Reviewers' comments:

Manuscript ID: **COMMSBIO-20-2668-A**

Title: **Pocket MUSE: an affordable, versatile and high-performance fluorescence microscope using a smartphone**

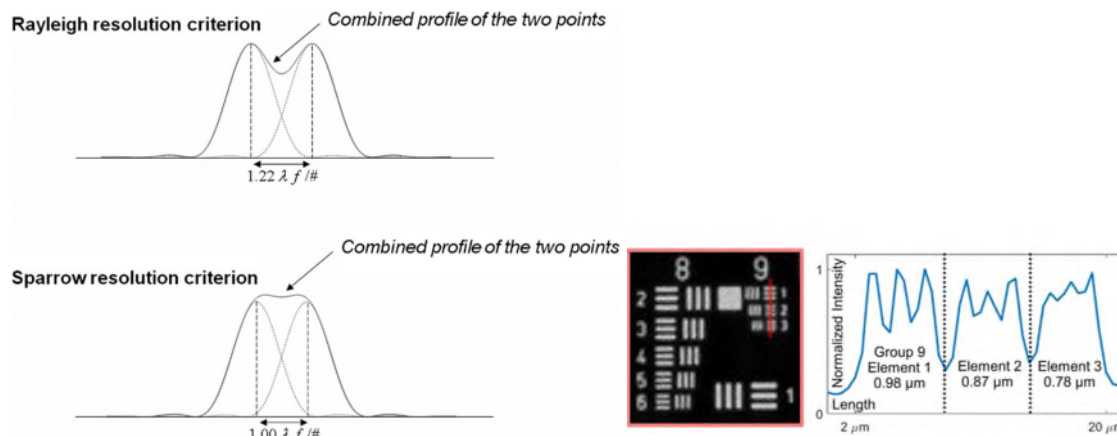
1. In abstract, submicron resolution is over claiming. The demonstrated resolution is only approaching to 1 μm . In figure 1i, you claim that element 2 is resolved but it won't be considered as resolved in FWHM sense. Even unclear if element 1 is resolved (not far at least though). Please clarify how you determined resolution.

There is no good standard for interpreting the USAF-1951 test images. Based on either the Rayleigh or the Sparrow (FWHM) resolution criterion, it is fair to claim the resolution of the system is less than a micron (see figures below). In figure 1i element 1&2, the resolution clearly surpass Sparrow criterion. We clarified the criterion in the figure caption.
